APPLICATION NO.	FILING DATE	FIRST NAMED INVENTOR	ATTORNEY DOCKET NO.	CONFIRMATION NO.
10/772,960	02/05/2004	Kenneth George Hodson	TI-37020	5315
23494	7590	06/09/2005	EXAMINER	
TEXAS INSTRUMENTS INCORPORATED			NGUYEN, THINH T	
P O BOX 655474, M/S 3999			ART UNIT	
DALLAS, TX 75265			PAPER NUMBER

Office Action Summary	Application No. 10/772,960	Applicant(s) HODSON, KENNETH GEORGE	
	Examiner Thinh T. Nguyen	Art Unit 2818

DETAILED OFFICE ACTION

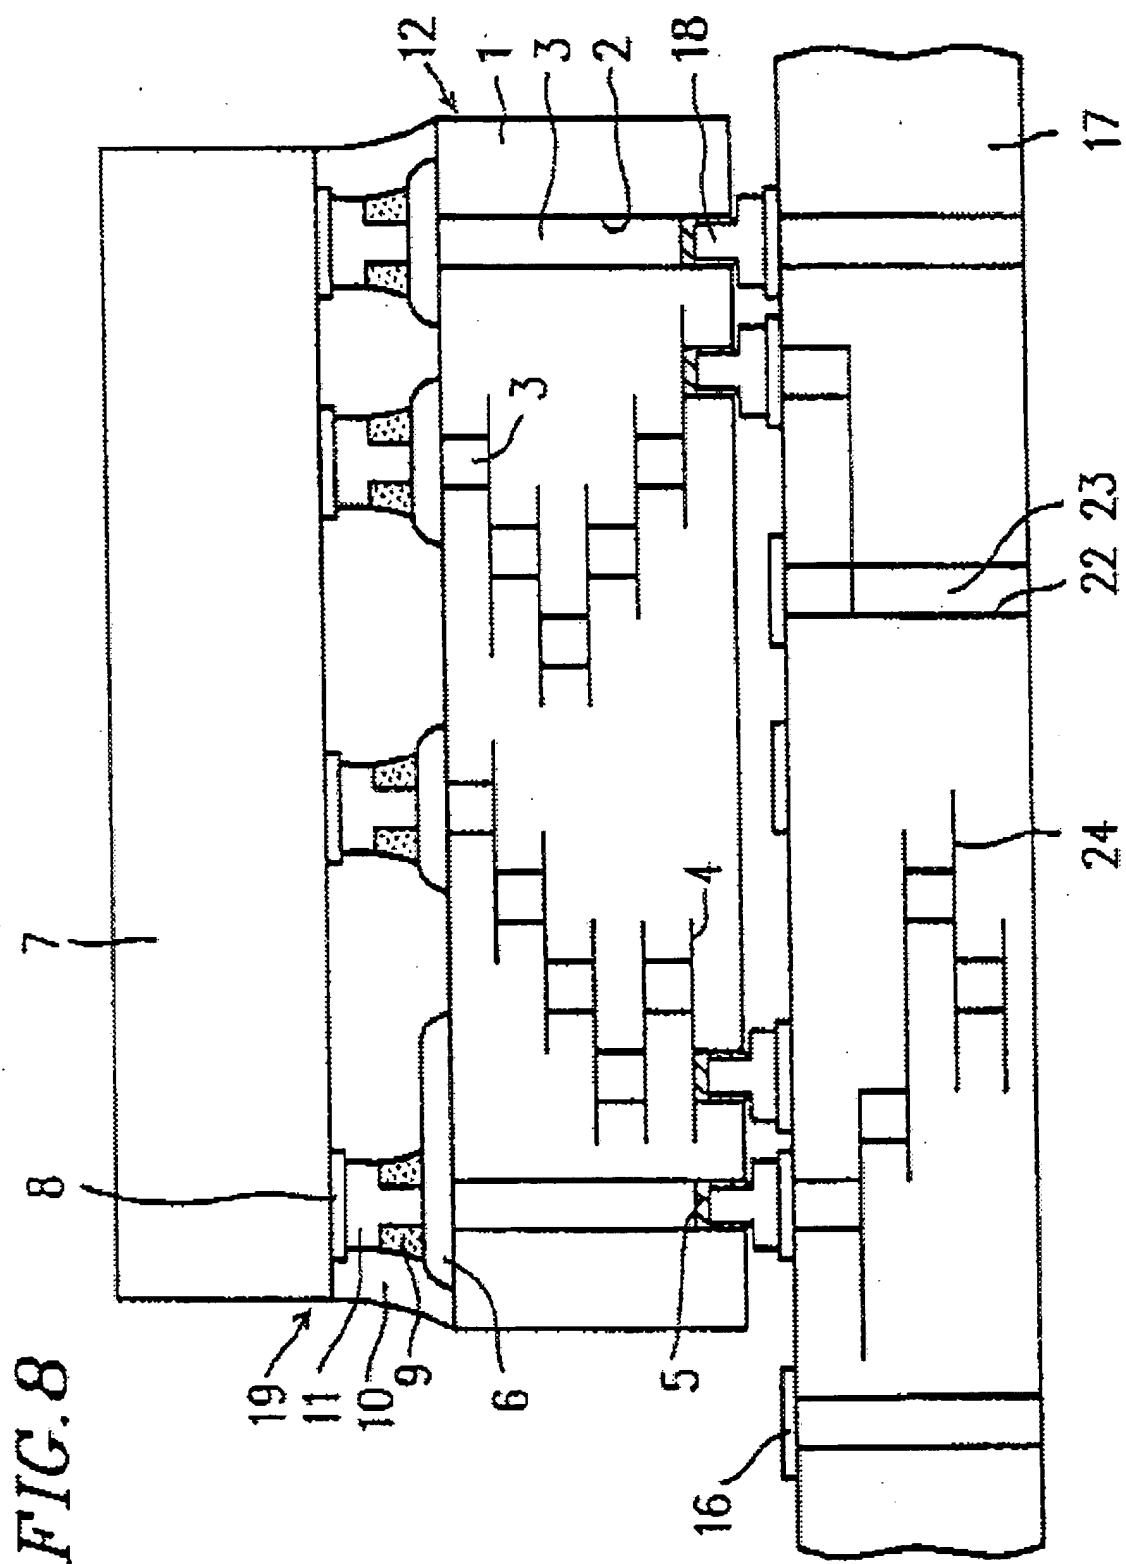
Tomura discloses (the abstract, fig 8, claim 7) a semiconductor assembly (fig 8 comprising: a IC (fig 8 reference 19) having a plurality of metallic sockets (fig 8 reference 5) arrayed on a mounting surface; a PCB (fig 8 reference 16) having a plurality of metallic projections arrayed on a mounting surface; wherein the PCB and IC are positioned so that a plurality of the sockets adjoin a plurality of the projections; and a plurality of solder joints coupling the IC sockets adjoining the PCB projections.

Similarly , Grabbe (the abstract, fig 2) the IC chip 40 metallic socket 44, metallic projection 52, discloses the same invention.

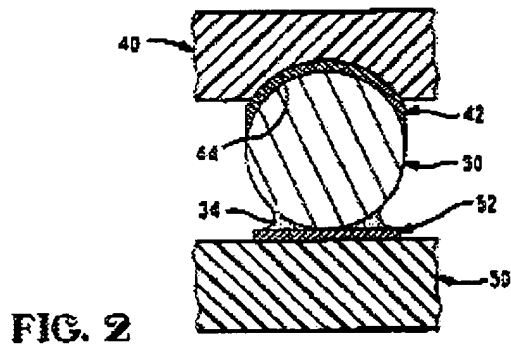
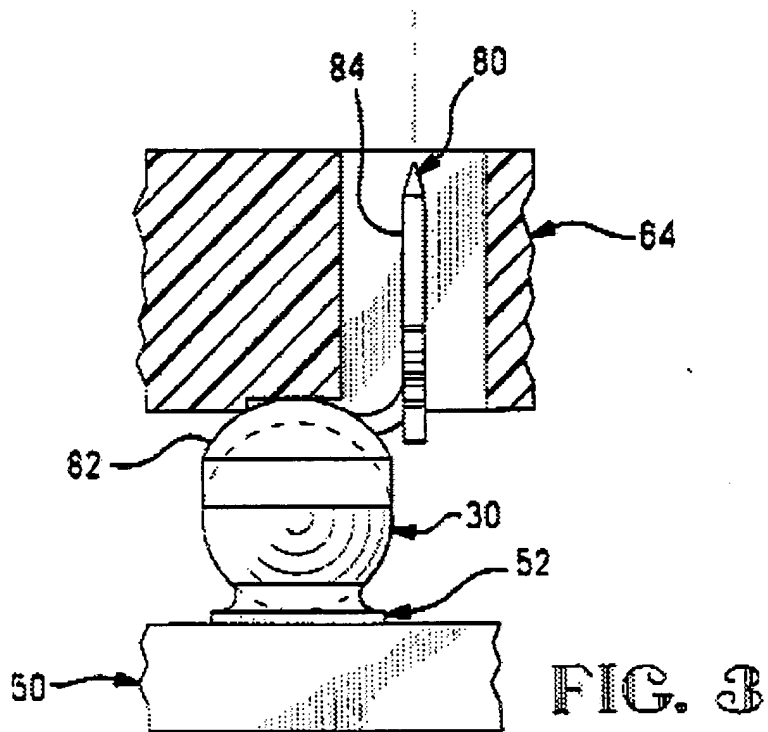
Tomura discloses (the abstract, fig 8) a semiconductor assembly wherein the solder joint are detachable.

Similarly , Grabbe (the abstract, fig 2,fig 3) discloses the same invention.
